ENGINEERING BULLETIN

Subject: Exalt/Gallant Vent Terminations Date: 7/27/21 EB0066

Fig. 12 - Direct Vent - Vertical Vent and Side Wall Combustion Air Termination

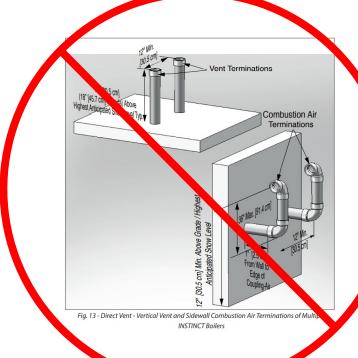
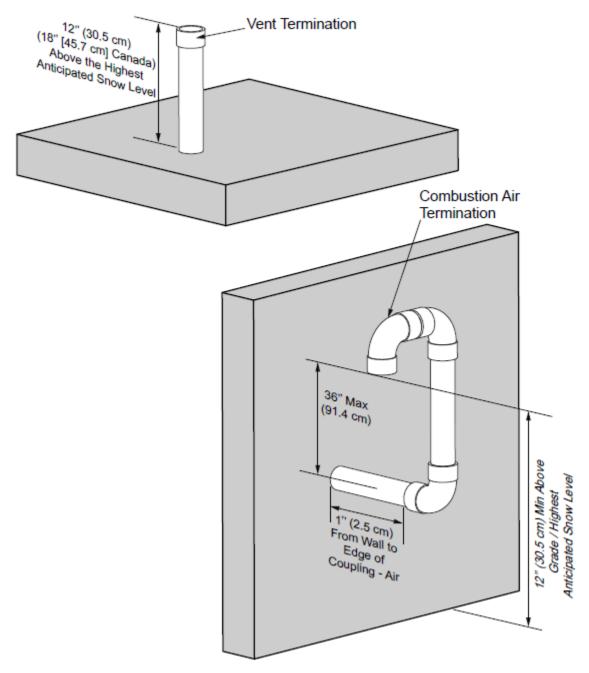
The Exalt Vent Guide and Gallant Vent Guide shows multiple installations where the combustion air termination comes out of the sidewall and terminates in the horizontal position (shown in Figs. 8, 12, 13). This should be shown with the combustion air termination with an additional 90° elbow pointing down toward the ground.

The Combustion Air Termination in the horizontal orientation may lead to rainwater getting into the piping under specific weather conditions.

Exalt and Gallant venting termination configurations in figs 8, 12, and 13 are no longer allowed. All affected installations should be adjusted so that the combustion air piping terminates with 180° bend with the intake opening facing the ground using two 90° elbows. The termination must be located 12" [30.5 cm] (18" [45.7 cm] in Canada) above the highest anticipated snow level.

These images are to be replaced with the following images:
